Service Bulletin.

OIL FILTER
B 16 engine

Supplementary plate in oil filter

1. Supplementary plate

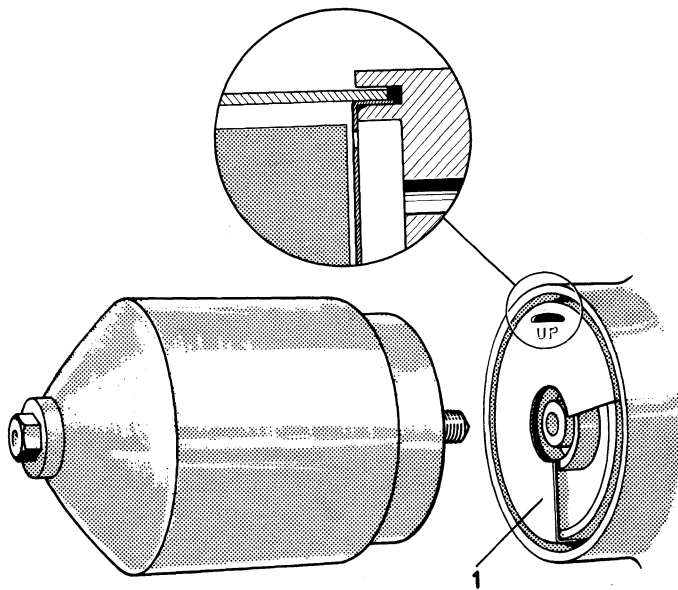
In order to obtain full oil pressure more rapidly after starting the engine, a supplementary plate (part number 418008 complete with gasket) inside the oil filter has been fitted from the later part of April.

The oil in the filter is thus prevented from running back into the sump when the engine is stopped, to the same extent as earlier. When the engine is started the pump has not so much oil to feed before the pressure starts to rise. This supplementary plate can be fitted also on earlier B 16 engines and this can be done, for example, at the same time as the oil is changed.

When fitting the oil filter, always make sure that the supplementary plate has the mark "UP" at the top as shown in the illustration.
